project: BRUNSWICK MILL DEVELOPMENT PHASE 1
scale: 1:200 @A1
drawn by: TC

title: LEVEL 1 PROPOSED
drawing number: L(20)201

status: STAGE 5 – CONSTRUCTION
job number: 0586
revision: C5

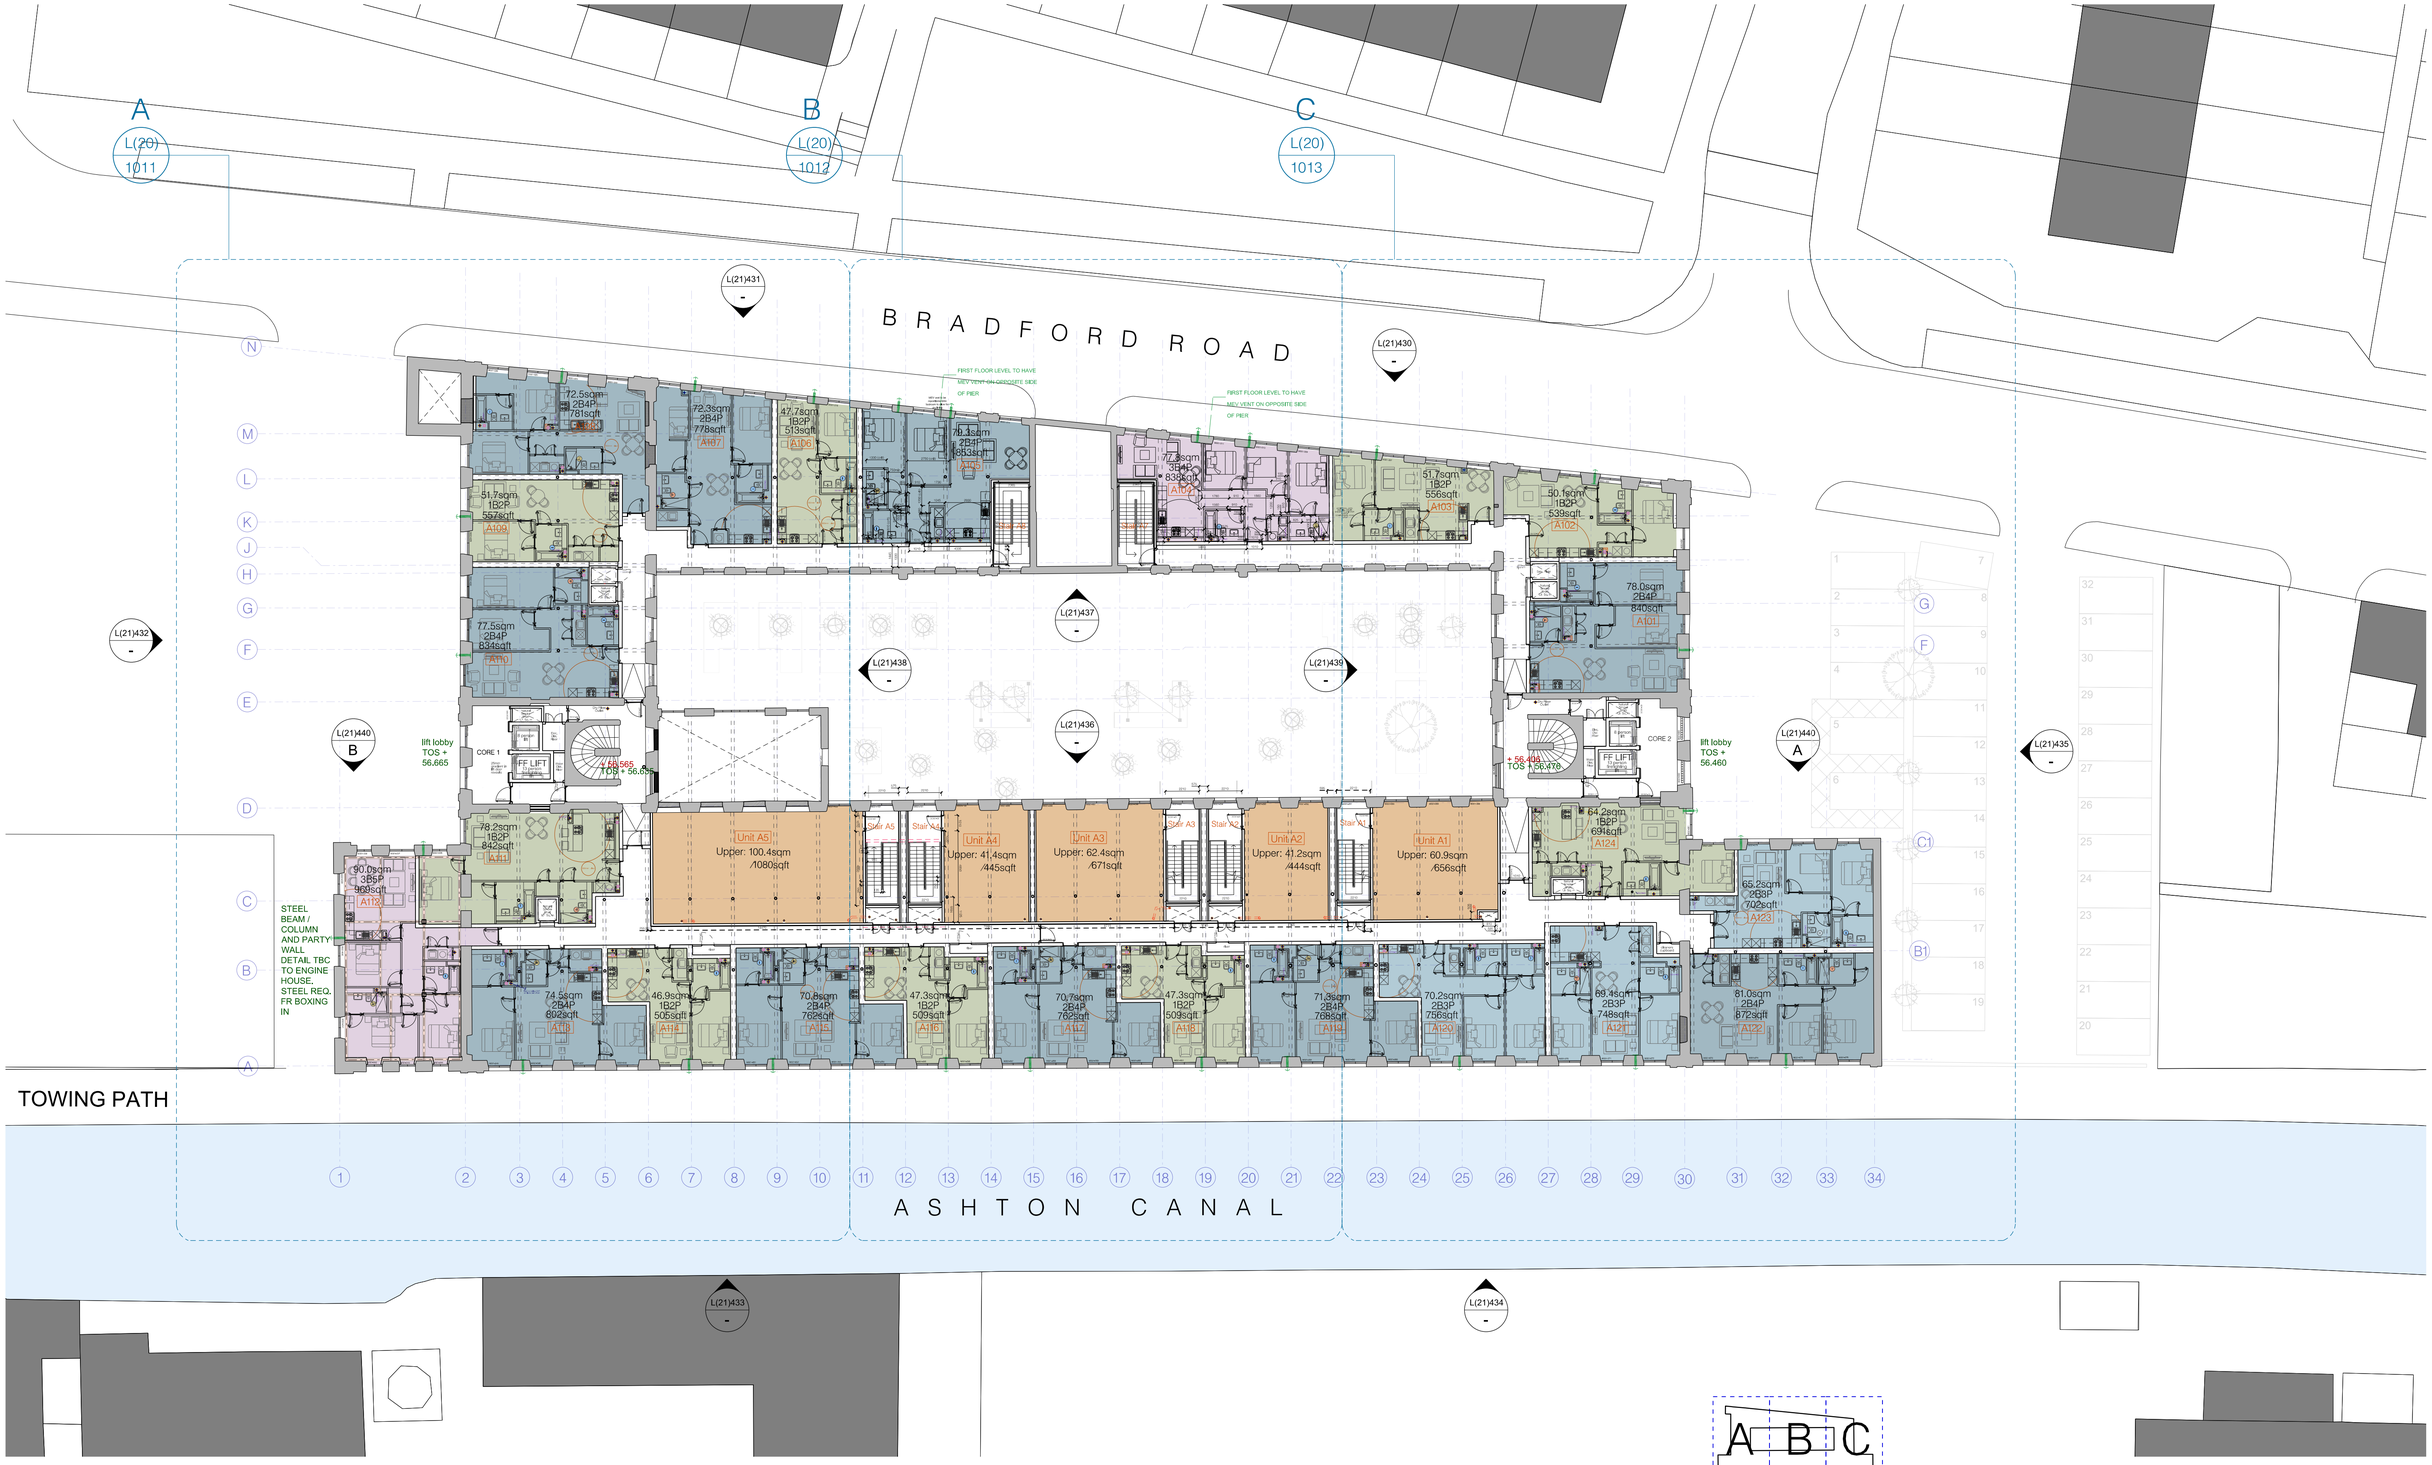
RWP (internal)
(Consolux to confirm pipe dia size and incorporate into design. HWC to incude in Civils drainage)

SVP SET OUT
Dimension indicates setting out of SVPs.
Dimensions set from centre of existing structural steelwork. Dimensions to the centre of the pipework.
Dimensions to be checked on site to ensure stacking of pipework. Diameter of pipework to M&E information. Acoustic lagging and boxing in to acoustic recommendations.

Substack position (typical dryline boxing out to extend to allow for substack)

Ground Floor
SVP shown in green identifies vertical drop adjacent to column. Pipe to be offset in soffit as identified.

Ground floor sub level pop up positions subject to site check to ensure avoidance of clash with existing foundations. SVP Pipe to be offset under new floor level for sub ground drainage, above the existing baseplate.
All SVP pop up locations subject to M&E stage 4/5 design coordination. Slab buildups and waterproofing strategy subject to Waterproofing specialist design. FR access panels to be added to corridors. Internal access where corridor access is not possible

CONSOLUX TO REVIEW ALL SVP SET OUT - SPACE BEHIND SHOWER SPACE. SPACING INBETWEEN SVPS FOR STRUCTURAL CORING. & N/E UNIT KITCHEN CHANGE. CONSOLUX TO UPDATE DWGS TO ALLOW FOR REFERENCE INTO ARCHITECTURAL DWGS

Localised SVP sub-stack boxing extension
